NRL/MR/7441--95-7711

Digital Mapping, Charting, and Geodesy Analysis Program Technical Review of Modernized Catalog System Softcopy Catalog Prototype Edition 1.0

February 9, 1996

Figure 1. VPF Tool comparison

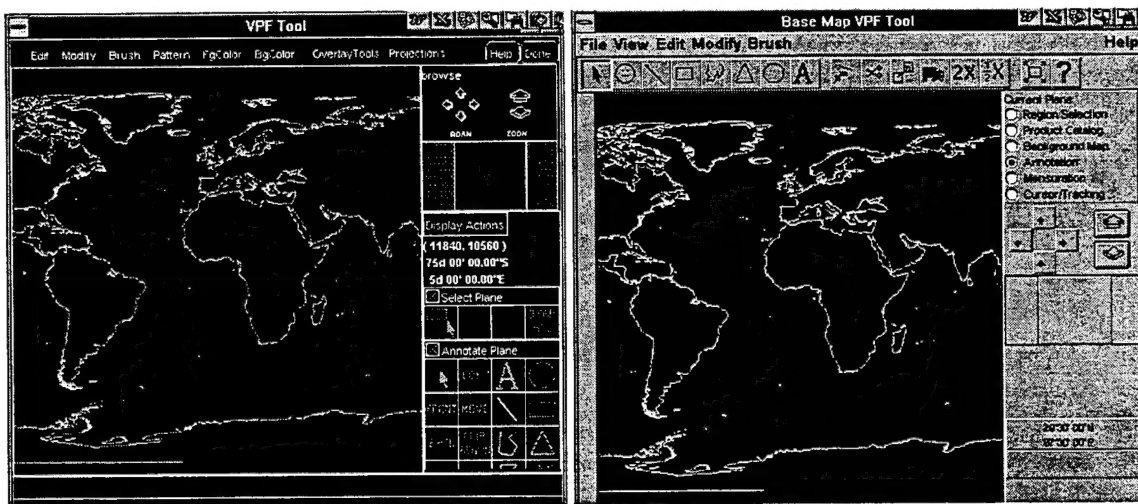
This is the second review performed by the Digital Mapping, Charting, and Geodesy Analysis Program (DMAP). Prototype 0.0 was completed in December 1994. Comments that were received on Prototype 0.0 after the report deadline are included in Section 5.0. These comments were also forwarded to DMA and are only included in this evaluation to capture them in the overall Navy / Marine Corps evaluation process. An overall comparison of the two prototypes is made in Section 3.0. A quick visual comparison of the Vector Product Format (VPF) Tool provided in Prototype 0.0 and the Base Map VPF Tool provided in Prototype 1.0 is shown in Figure 1.

Figure 2. First example of selected products

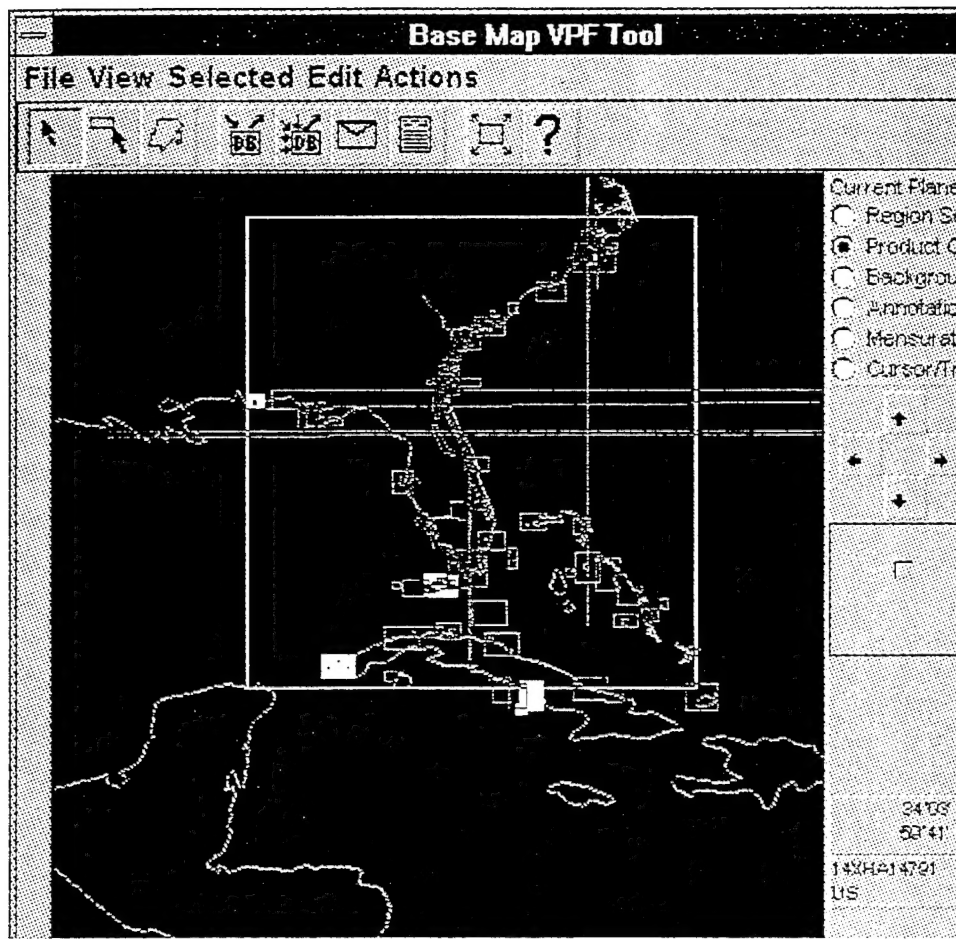
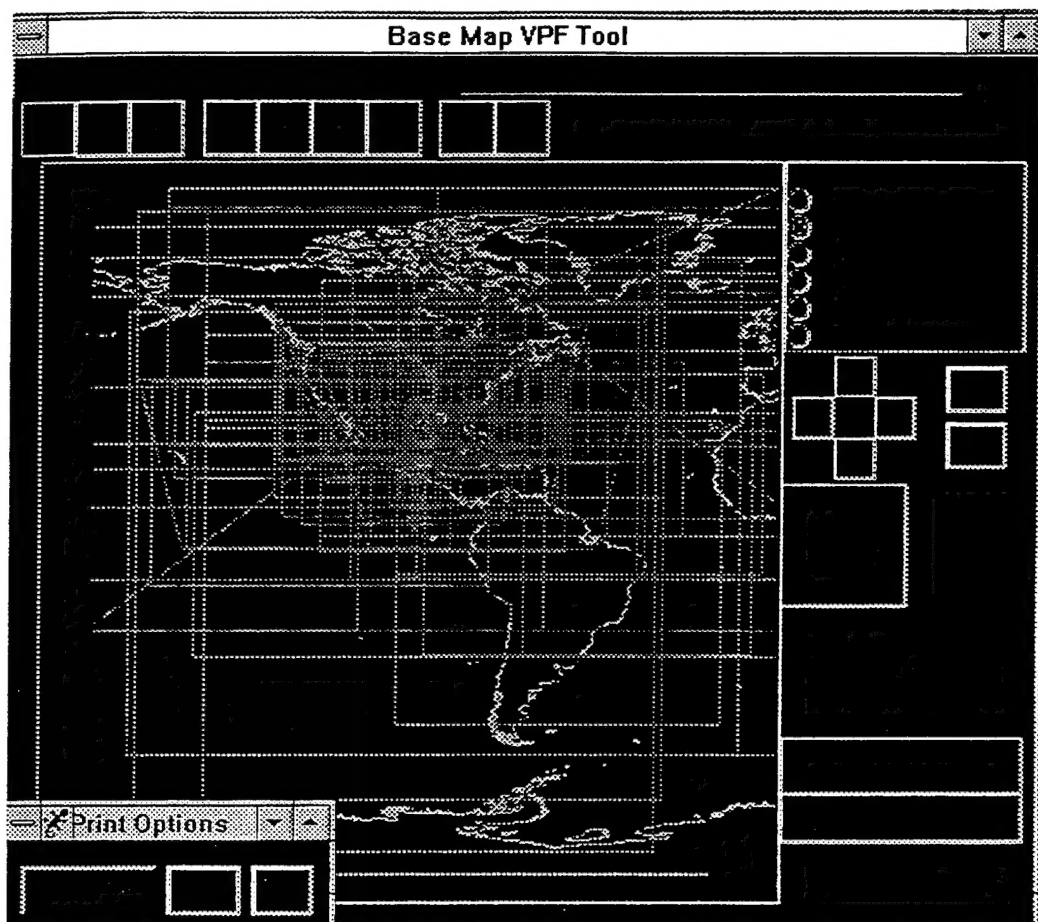
When performing a Single Query with only one product line selected, the footprint drawn was not what was expected (appeared to be a graphics problem.) Multiple squares/lines were drawn, some never ending (Figures 2 and 3).

Figure 4. Example of multiple windows printed

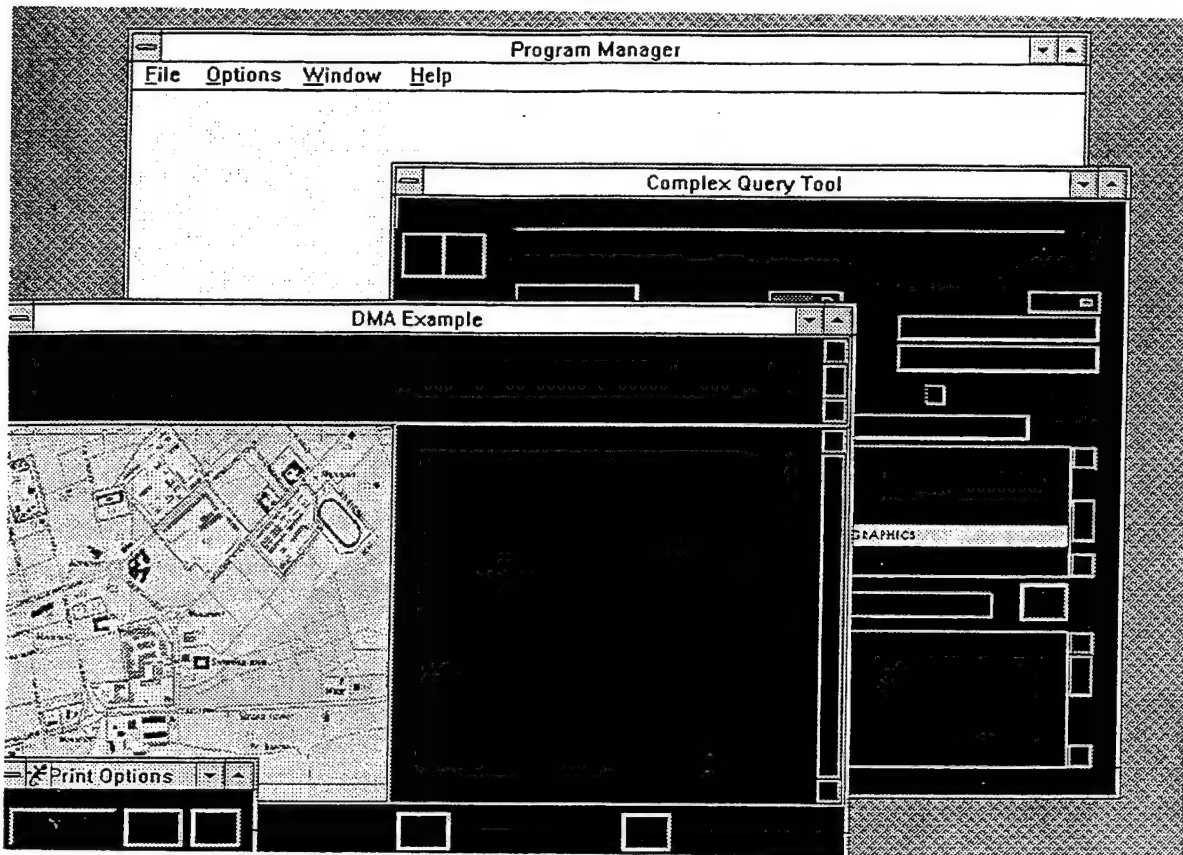
When printing screens, the preferred print action would be to include only the top opened window, not to print all open windows, including the Program Manager (Figure 4).

Figure 5. First example of blackened text area

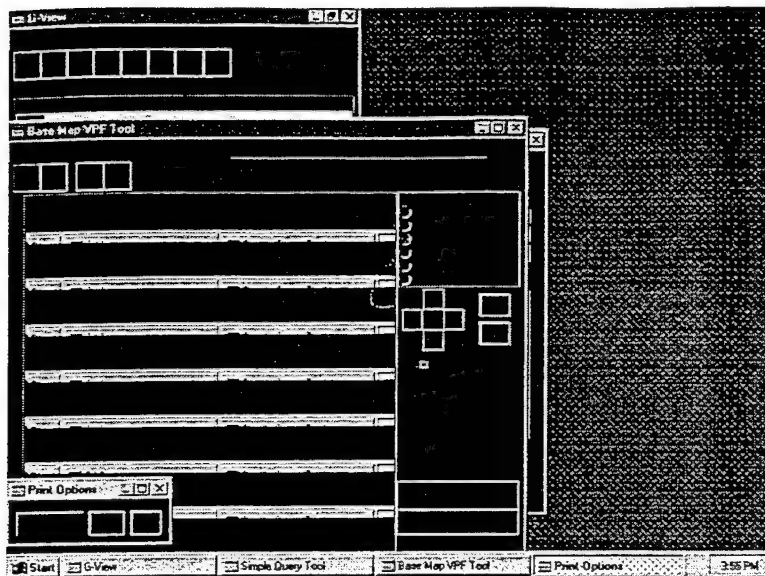
When screen printing, the textual area was blackened and text could not be read. When using the cursor arrows to bring the image up on the screen (Windows 95 operating system), the tip of the Windows 95 toolbar was dragged onto the screen (Figure 5).

Figure 6. First example of print window option

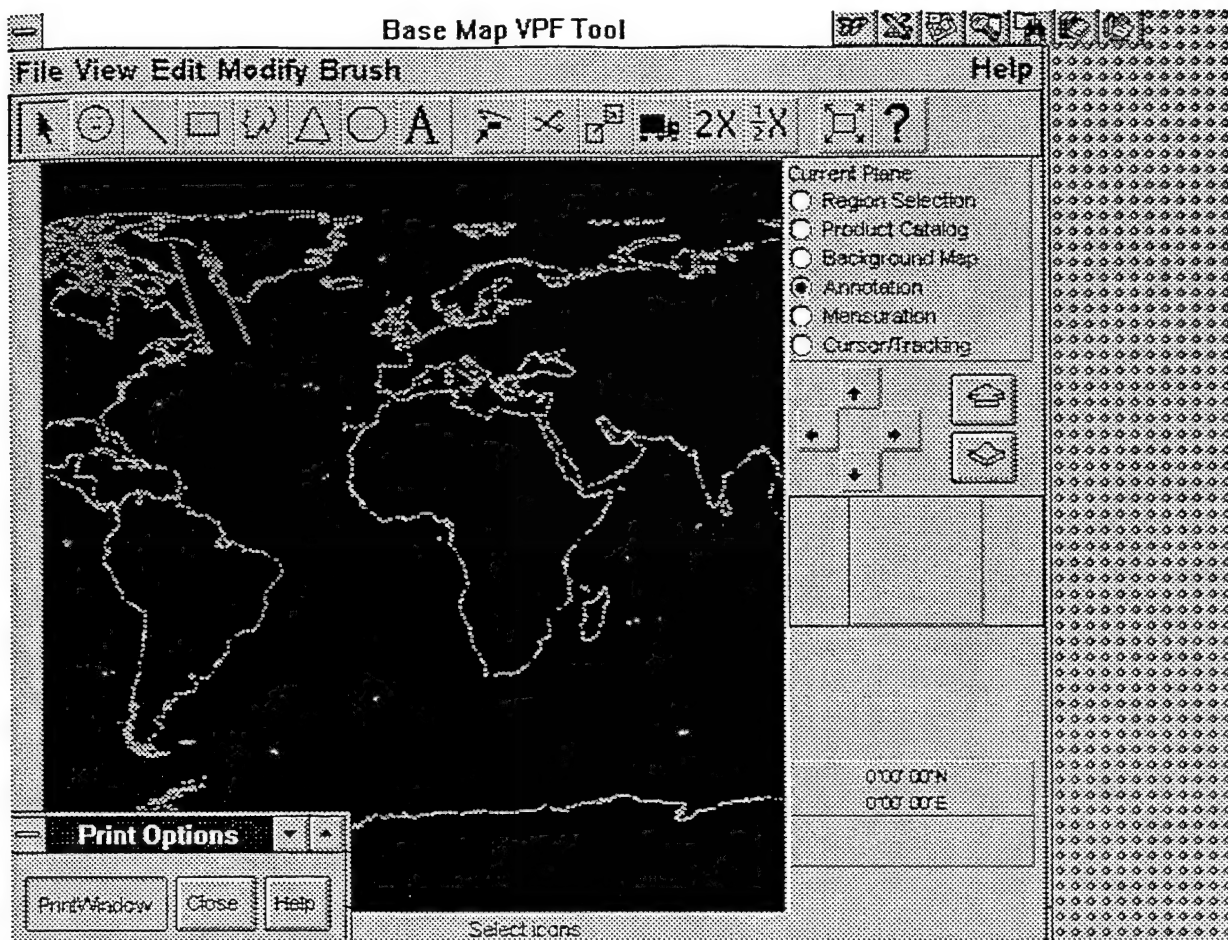
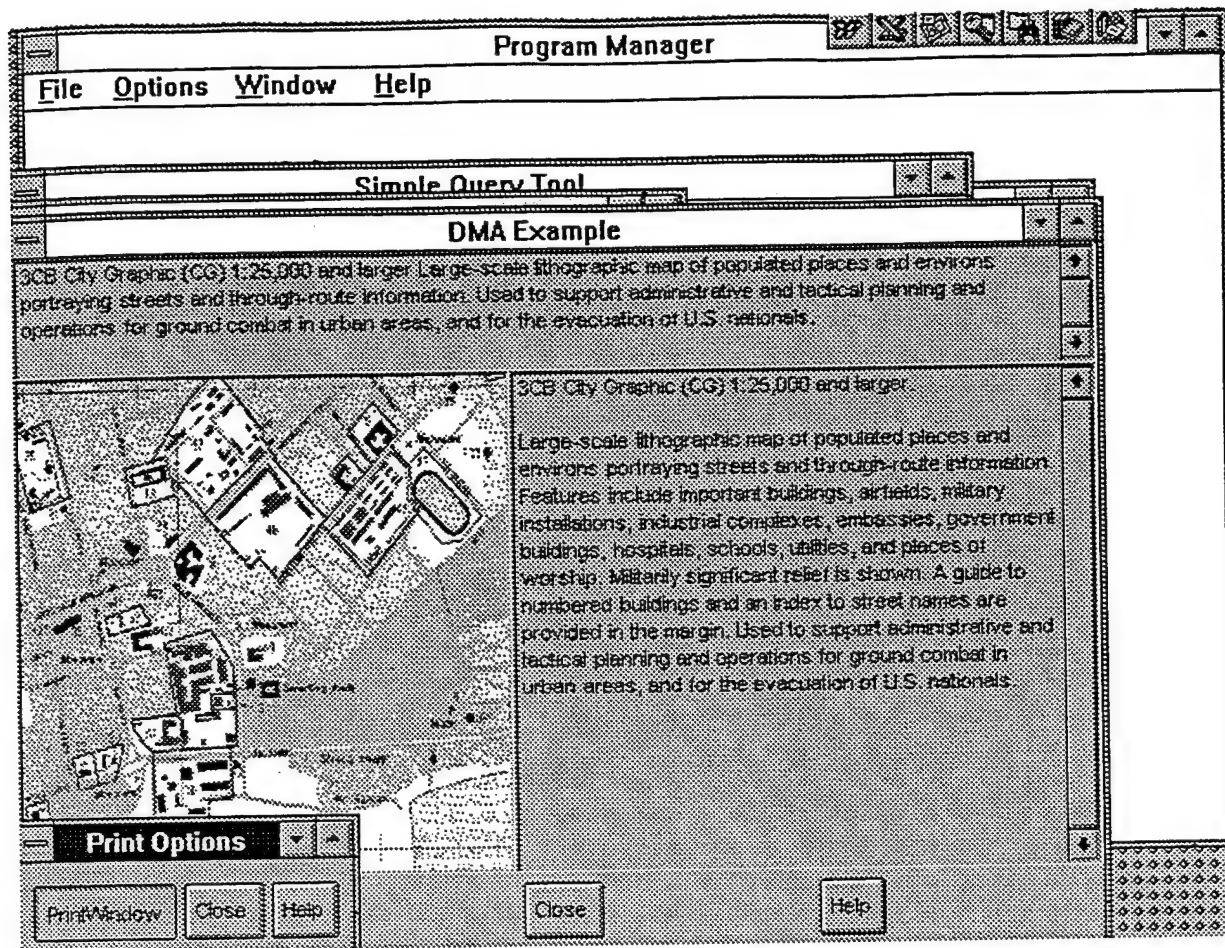
The *print window* option not only prints the window, but also the whole screen including the Program Manager background and every other open window (Figures 6 and 7). The option should be called *print screen* or, preferably, changed to "only print the selected top window." Also, the printout is not adjusted to the paper size (see examples in Figures 10 and 11). A feature could be offered to print landscape, letter, legal, executive, etc.

Figure 9. Second example of blackened text

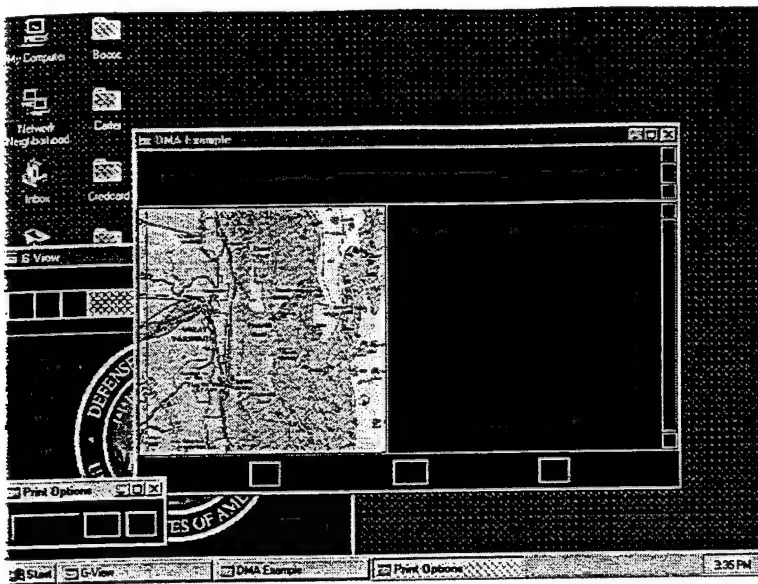
When using a Hewlett Packard LaserJet 4, the background default overwrote the printed text (Figures 9 and 10). Figure 11 shows the same problem using Windows 95.
